1110 BARRENJOEY ROAD – PALM BEACH, NSW
ARBORICULTURAL ADDENDUM REPORT
Ref No: 10721

This addendum report has been requested by Jorge Hrdina Architects. The purpose of this report is to address design modifications adjacent neighbouring trees 21 & 22, with this report confirming review of latest design plans as referenced below.

Figure 1, T21 & 22 management areas

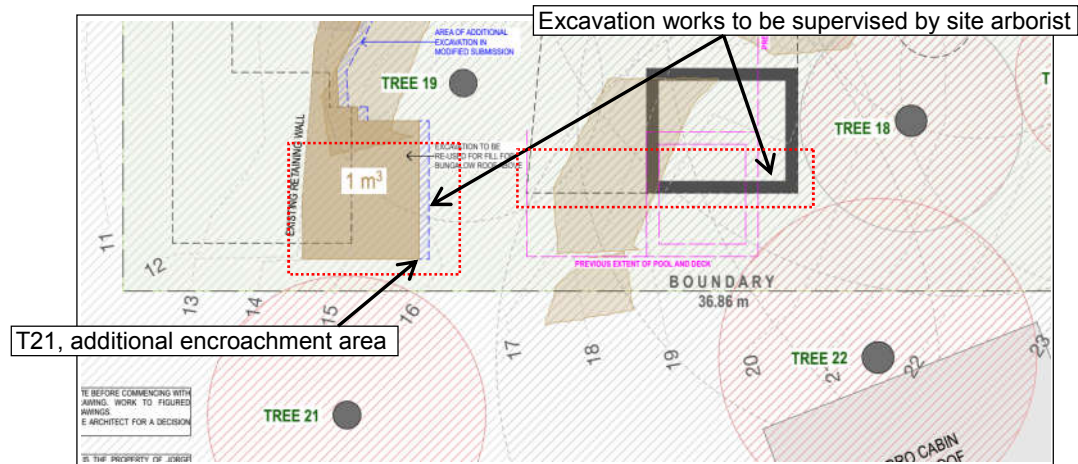
Tree 21: As shown within Figure 1 the additional minor encroachment at or near 245mm from the existing footprint will unlikely affect the vitality of the tree.

Tree 22: The location of the amended swimming pool footprint has Minor (<10%) at or near 7.5% Tree Protection Zone (TPZ) occupancy, of low level impact and encroachment within TPZ.

Tree management: The management of the trees during works is to consist of all recommendation provided within Raintree Consulting's Arboricultural Impact Assessment (AIA) report specific to:

- 1) The extent of existing retaining wall demolition, new all construction and any over excavation required to accommodate the design proposal shall be clearly marked within construction drawings prior to obtaining a Construction Certificate (CC).
- 2) An appointed project arborist shall be engaged to supervise excavation within tree protection zone setbacks with all encountered tree roots protected in accordance with AS4970 – 2009 Section 4.5.4 *Root protection during works within the TPZ*, such that tree roots are not damaged or ripped beyond the point of excavation by site machinery. Root pruning should also be conducted in accordance with Section 9 of Australian Standards AS 4373 Pruning of Amenity Trees 2007 specific to: all cuts shall be clean cuts made with sharp tools such as secateurs, pruners, handsaws, chainsaws or specialized root pruning equipment.

Figure 2, showing amended pool location & roofline adjacent T8

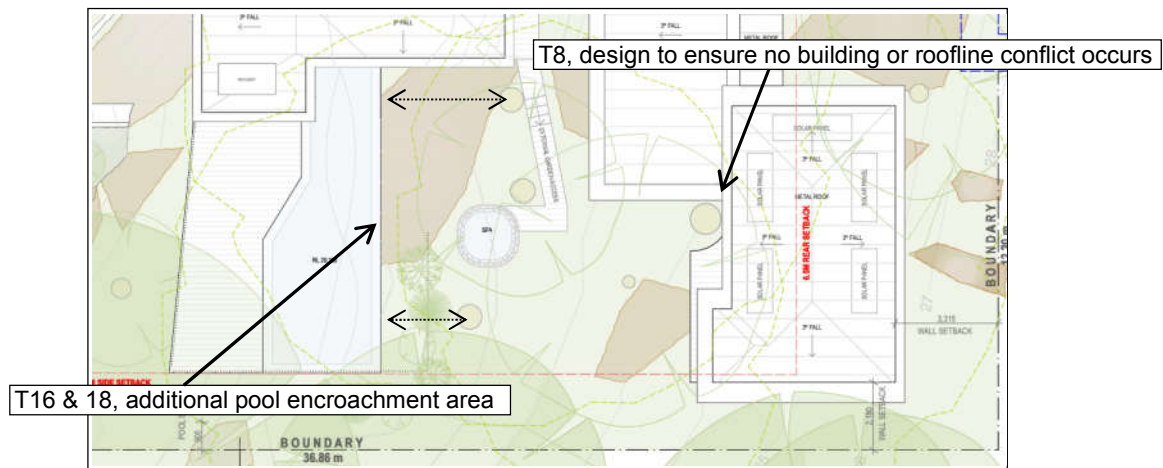
Amended pool location, trees 16 & 18 [Plan DA2002].

The amended pool location slightly increases TPZ occupancy and potential impact. Further information is required based on pool construction methodology with design plans showing how the pool will be constructed to mitigate impacts within tree protection zones. Prior to obtaining a Construction Certificate (CC) final pool construction drawings are to be reviewed and endorsed by an appointed project arborist.

Tree 8, Roof Plan [DA2005]

Design is to ensure no building or roofline conflict occurs where suitable space is to provided that allows for ongoing natural tree growth.
